INVITATION FOR BIDS
CCK-2563.30-7-25
CTC + AAC BP07 Core & Shell Group 2
Project# 2563.30
ADDENDUM #2
09/12/2024

Addendum #02

Client	University of Kentucky Healthcare	Date	09/11/2024
Project	UK CTC BP-07 Core and Shell Group 2	UK Project #	2563.0
		Champlin Project #	514-5350

SHEET NO.
A200.B

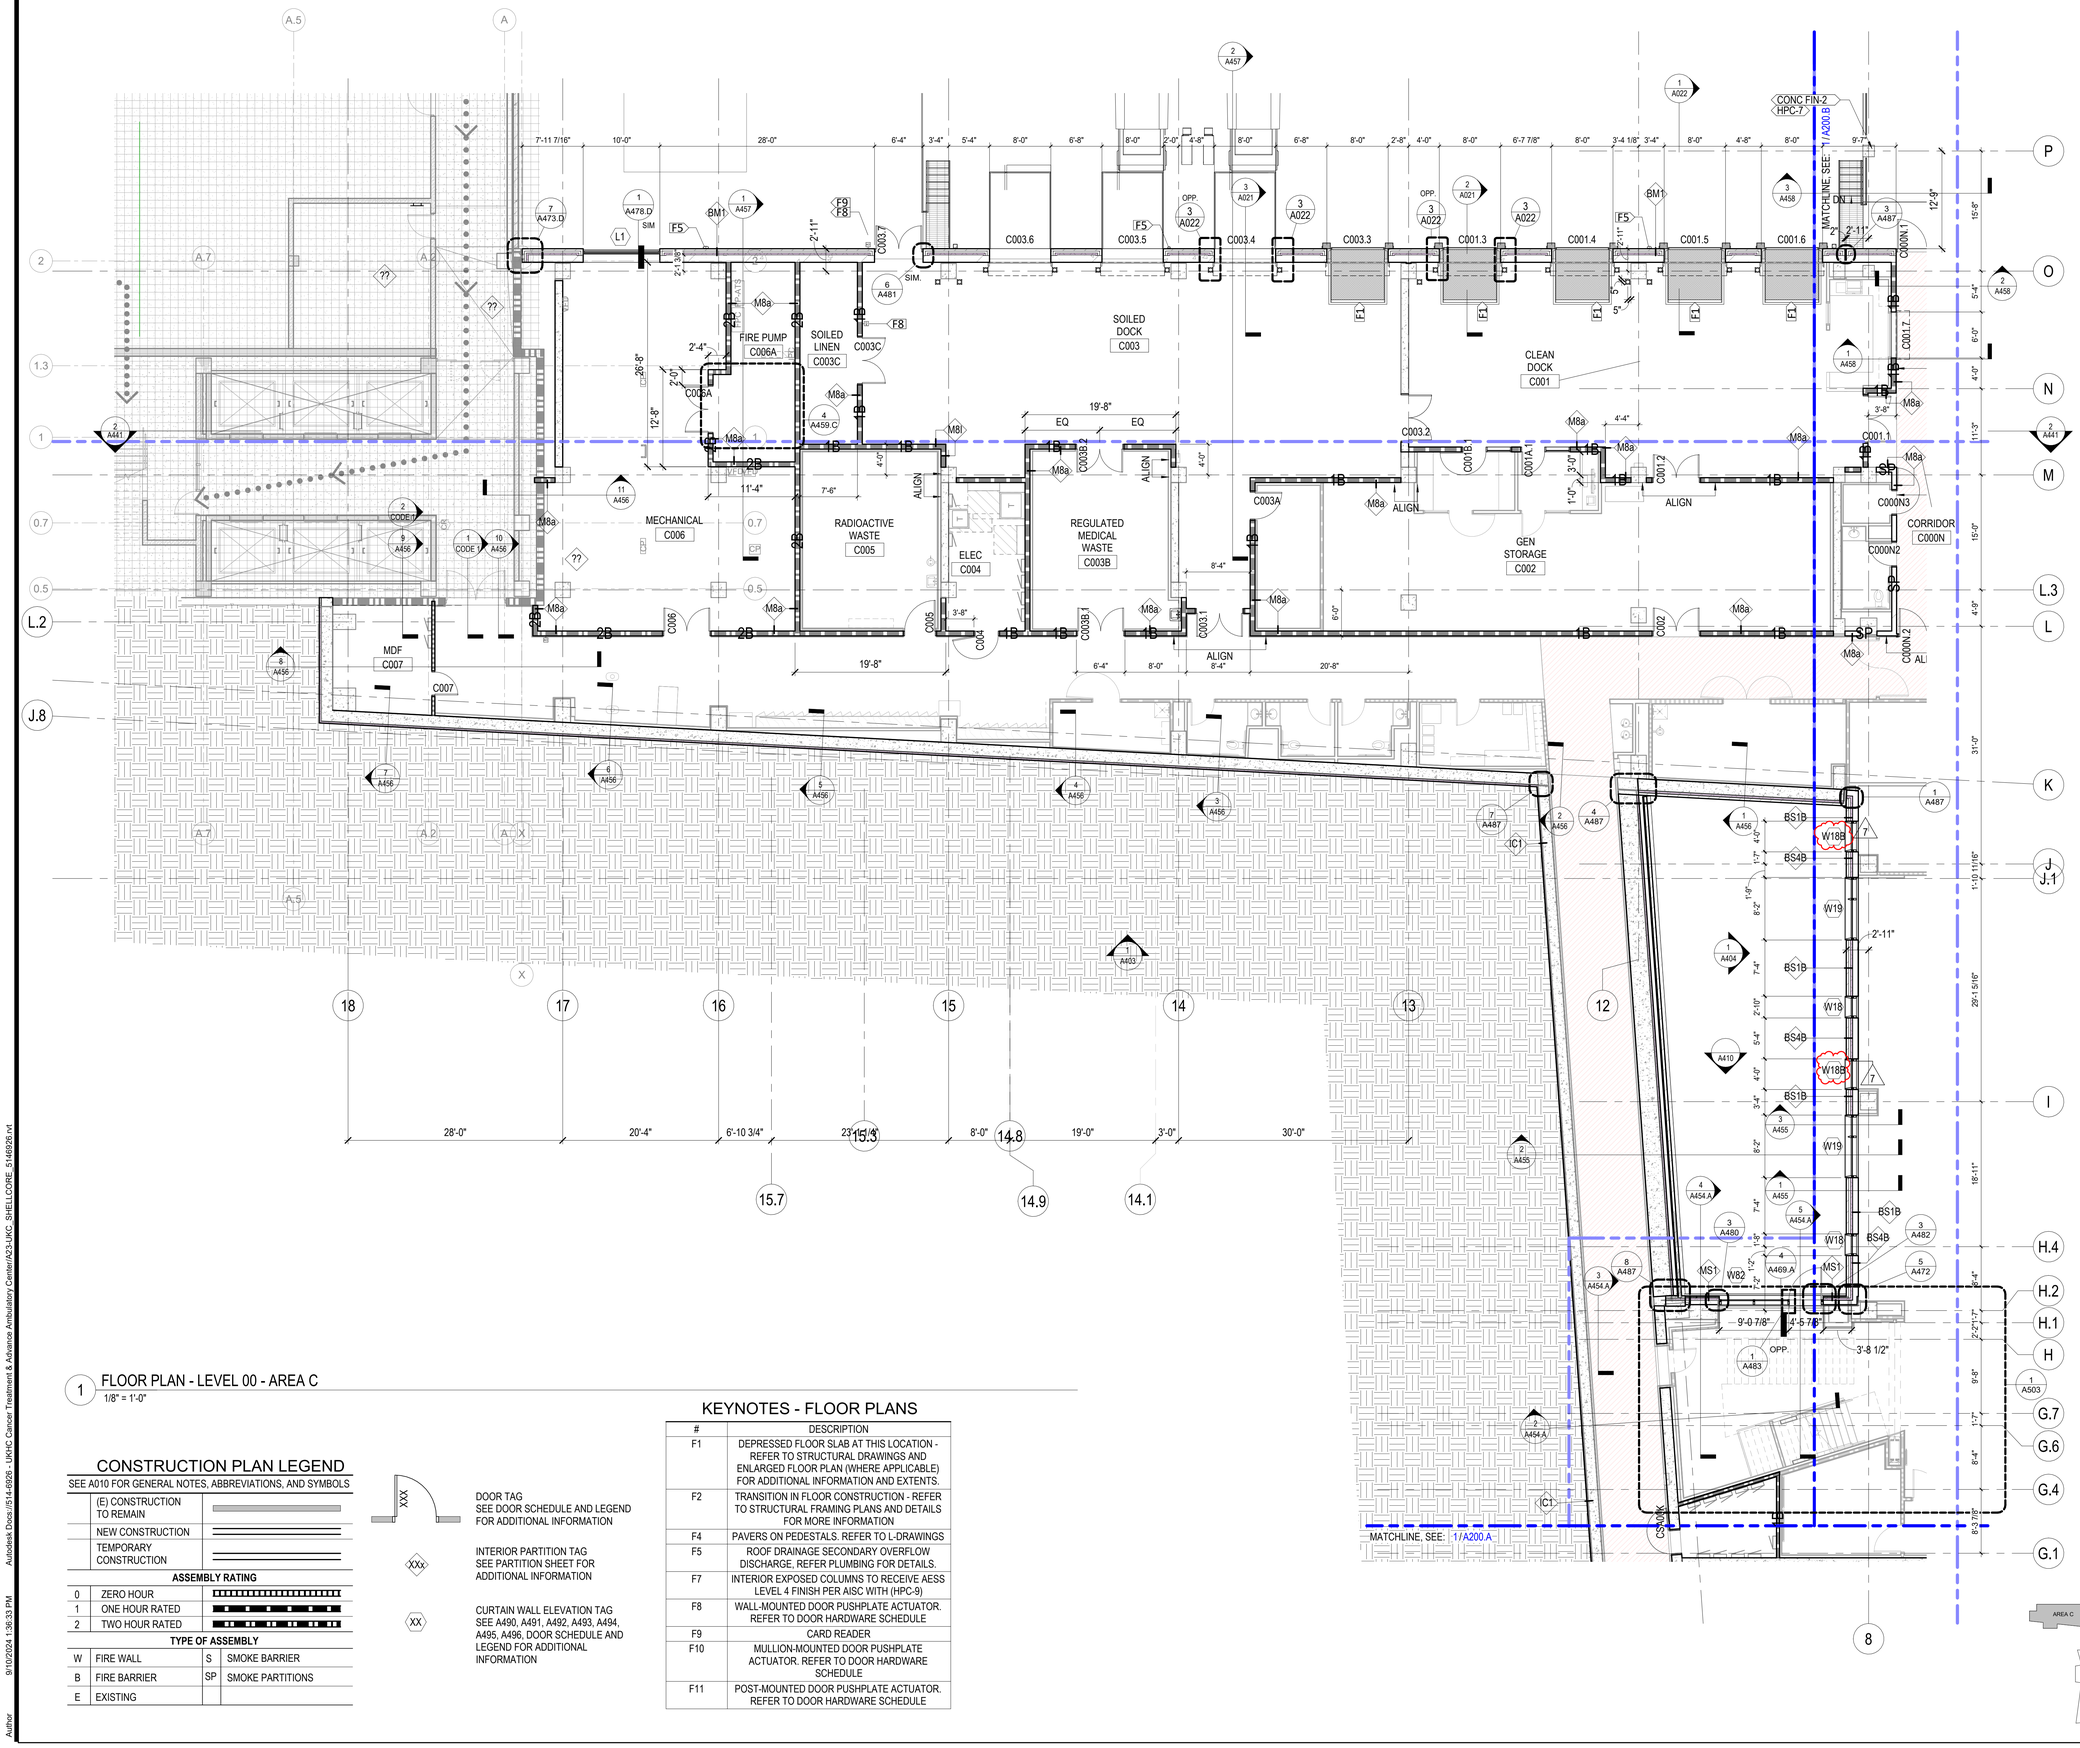
A200.B-SHELL & CORE FLOOR PLAN - LEVEL 00 - AREA B

1. *Revise curtain wall elevation tags*.

SHEET NO.
A200.C

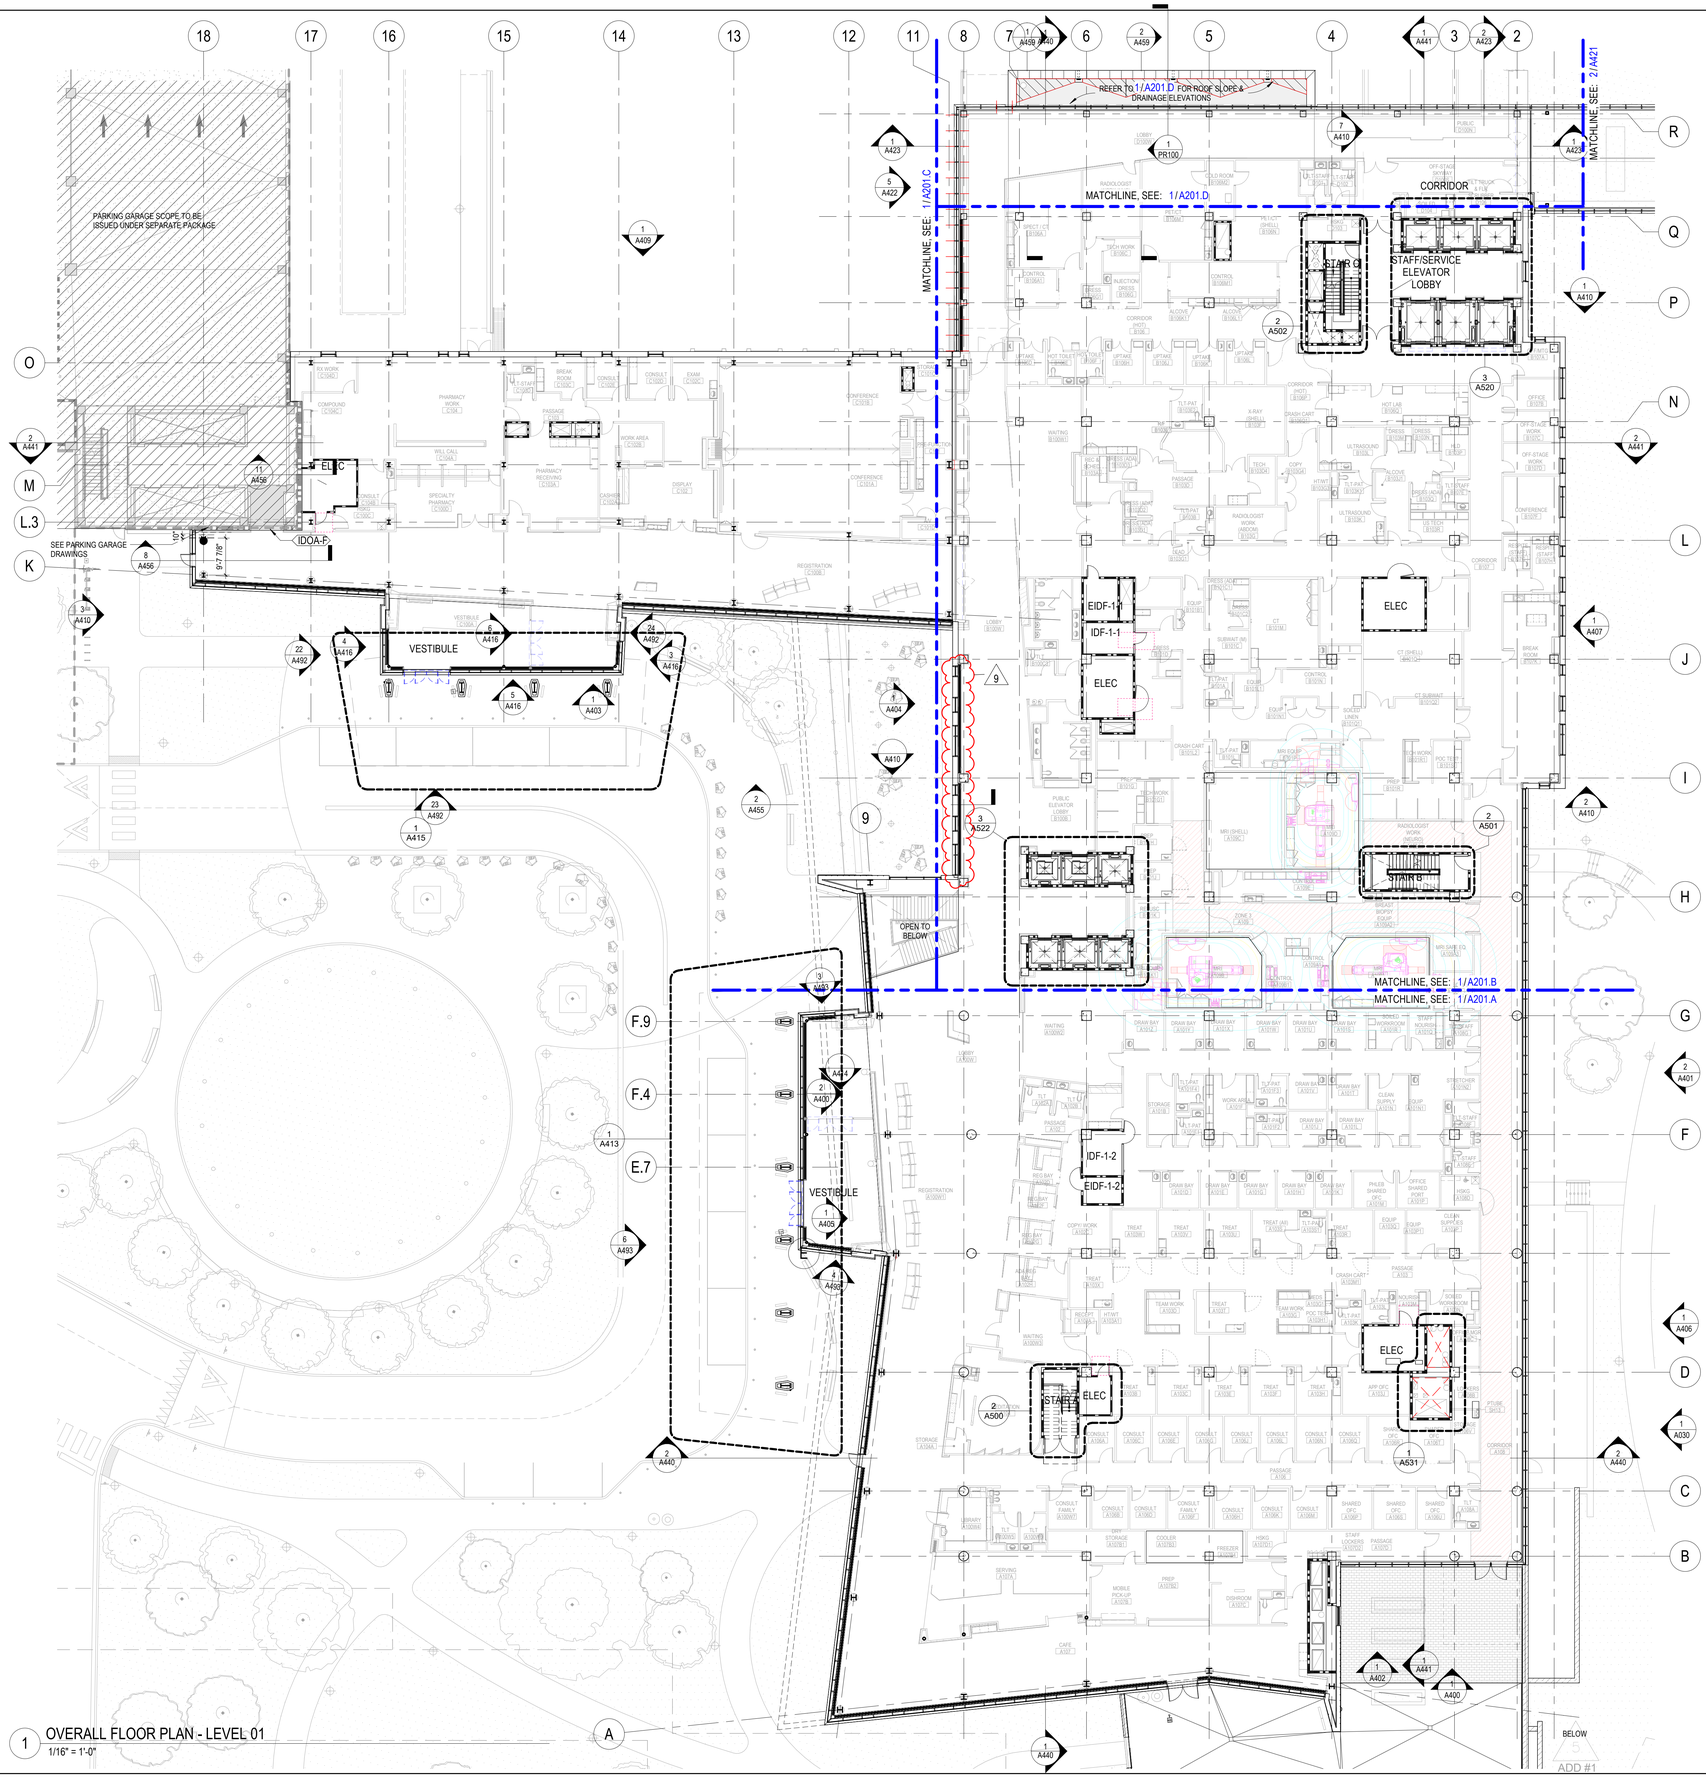
A200.C-SHELL & CORE FLOOR PLAN - LEVEL 00 - AREA C

1. Revise curtain wall elevation tags

1 OVERALL FLOOR PLAN - LEVEL 01
1/16" = 1'-0"

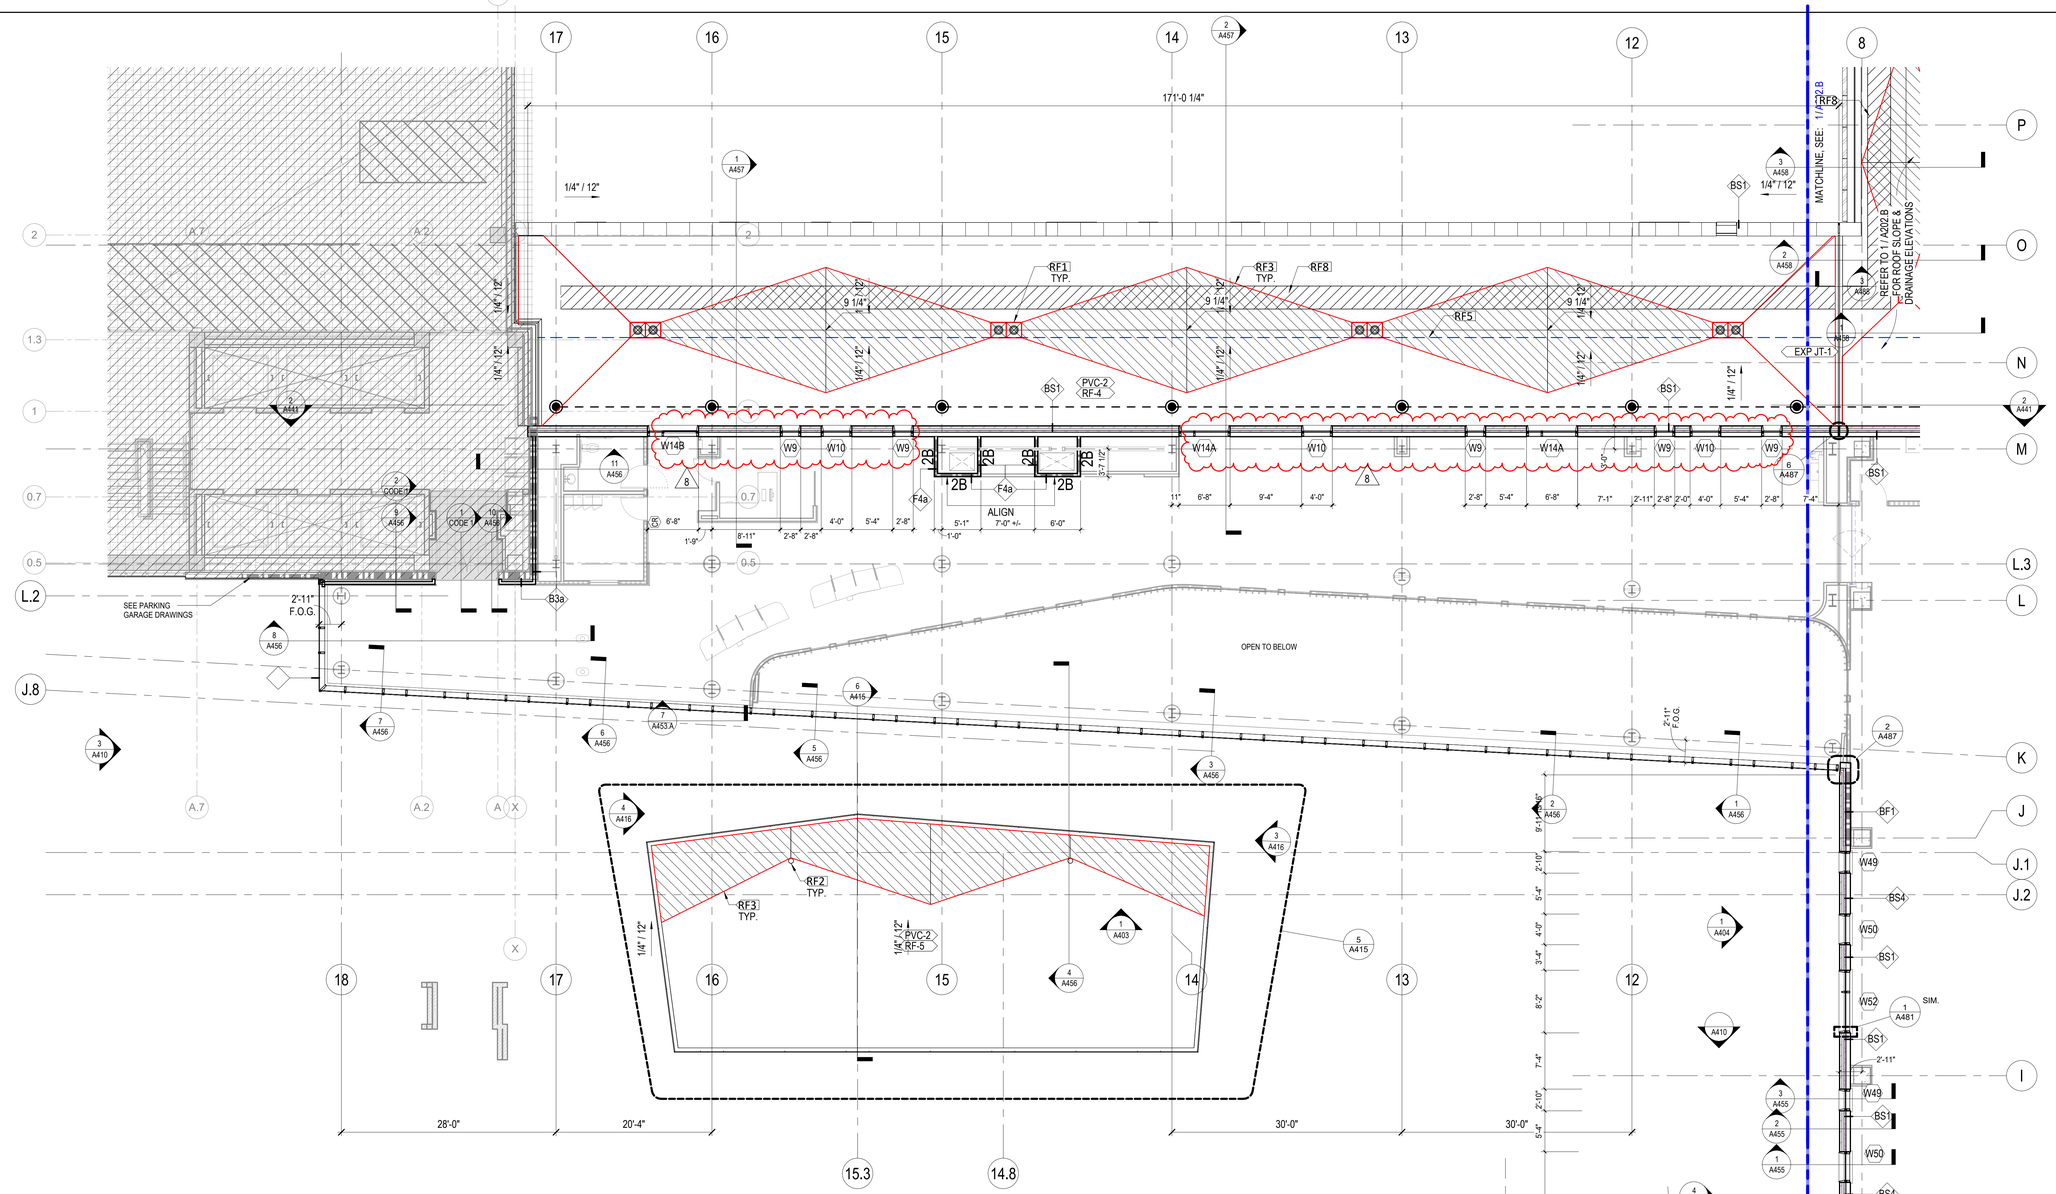
A201 – OVERALL SHELL & CORE FLOOR PLAN - LEVEL 01

1. Added fin tubes along curtain wall openings adjacent to sunken garden (grid line 8).
